# **STOKEINTEIGNHEAD DRAFT FLOODING REPORT PUBLIC CONSULTATION**

## **With DCC responses**

**15<sup>th</sup> October - 28<sup>th</sup> October 2015**

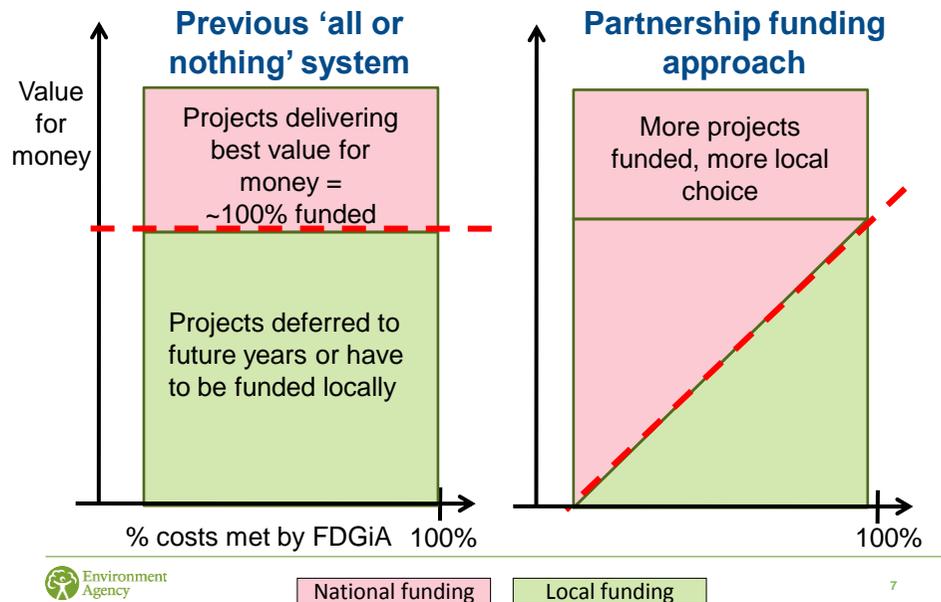
- **Possibility of providing photographs of any similar projects.**

Please see below example of a flood defence bund and dry storage area. This would be filled with water only in flood conditions.
